## Specification Change Notice

**Products affected: Liquidtight junction box JB-WLQ Option Pressure adjustment plug**

Dimensional drawing

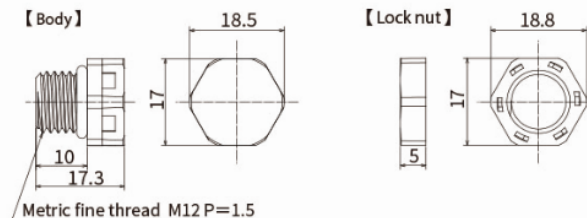
Model	Current	Replace
	JB-FVF1	JB-BVF1
Material		
Body	Nylon 6 ( Flammability UL94V-0 )	Nylon 66 ( Flammability UL94V-2 )
Filter	PES	ePTFE
O ring	Oilproof type NBR	Oilproof type NBR
Locknut	Nylon 6 GF30	Nylon 66 ( Flammability UL94V-2 )
Weight	4 g	3 g
Q'ty/package	1 pc/ package
